MONTGOMERY COUNTY PLANNING DEPARTMENT
THE MARYLAND-NATIONAL CAPITAL PARK AND PLANNING COMMISSION

MEMORANDUM

REVIEW TYPE: Preliminary Plan of Subdivision

PROJECT NAME: Martins Property
CASE #: 120070450
REVIEW BASIS: Chapter 50, Montgomery County Subdivision Regulations

Attachment B

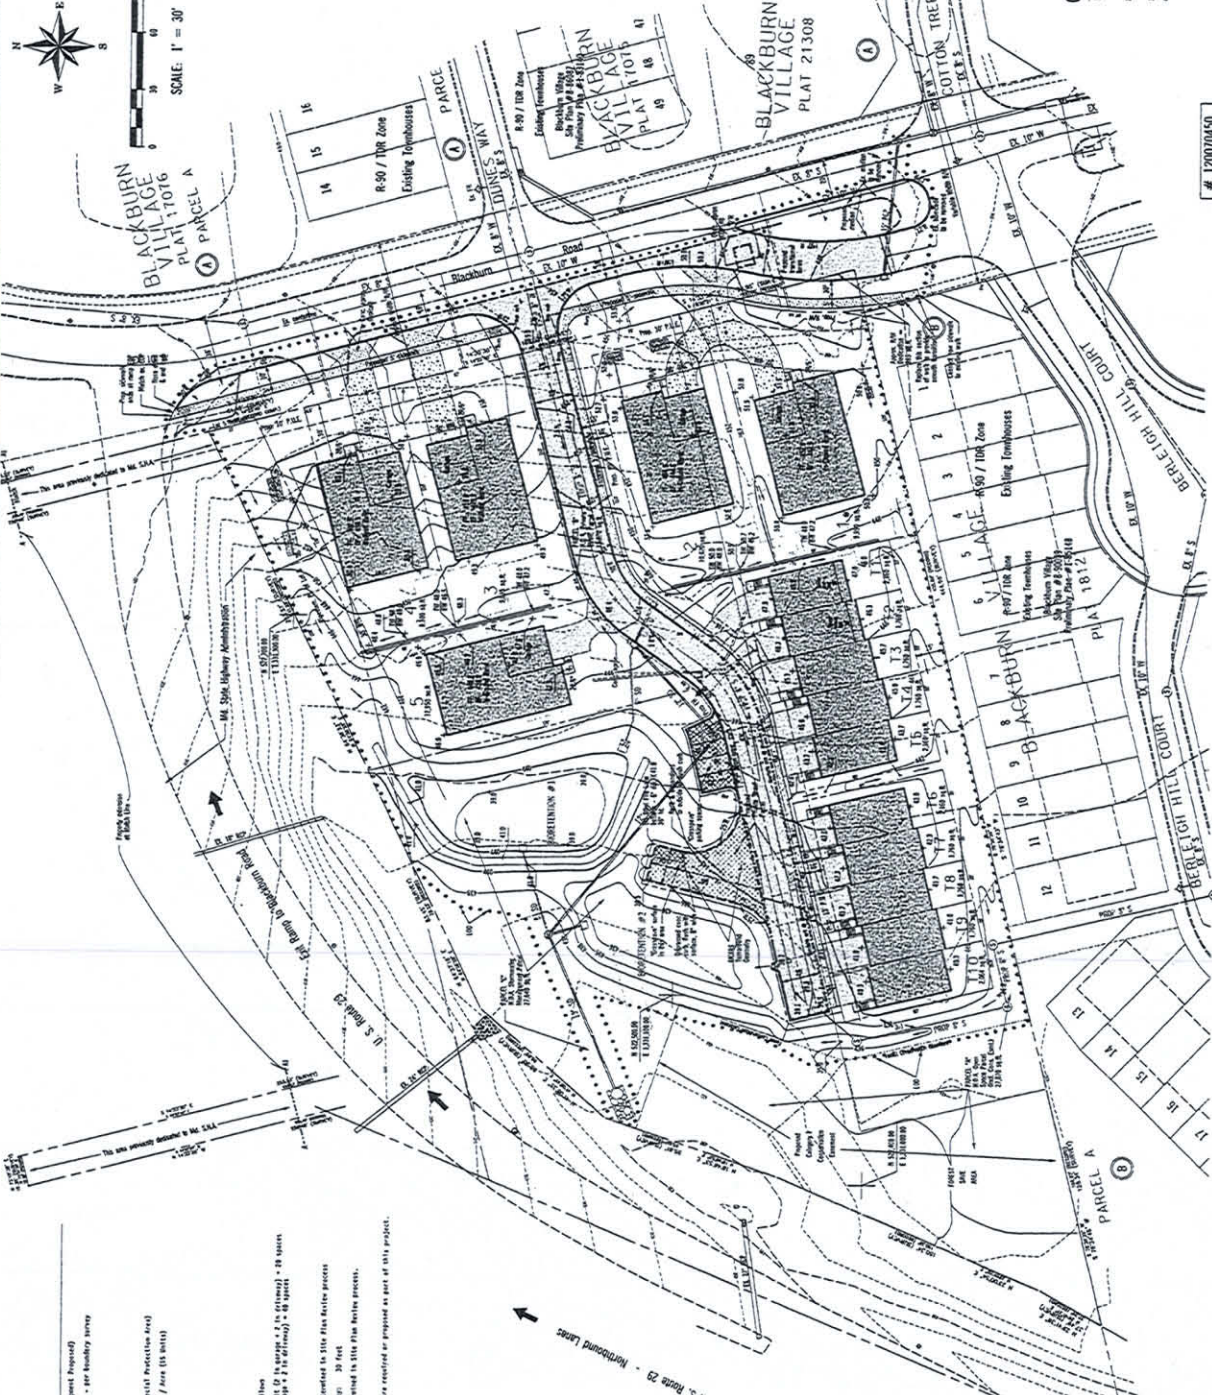
- 7) Prior to certification of the preliminary plan, the site data on the plan must be revised to accurately reflect the gross tract area, area previously dedicated to public right-of-way, area proposed for dedication to public right-of-way, and net tract area.

- 8) The applicant must dedicate and the record plat must show dedication of approximately 930 square feet of right-of-way along the property frontage for Blackburn Road to create a variable width right-of-way, as shown on the approved preliminary plan.

- 10) The applicant must construct all private streets to the widths shown on the preliminary plan, including the typical sections shown on the preliminary plan. The streets must be built to the structural standards of a tertiary road, as specified in Section 50-25(h) of the Subdivision Regulations.

- 11) The applicant must construct five-foot wide sidewalks along the proposed private street, along the Blackburn Road frontage of the subject property, and along the west side of Blackburn Road from the northwest corner of the intersection of Blackburn Road and the US 29 exit ramp to the current southern terminus of the existing sidewalk north of the subject property.
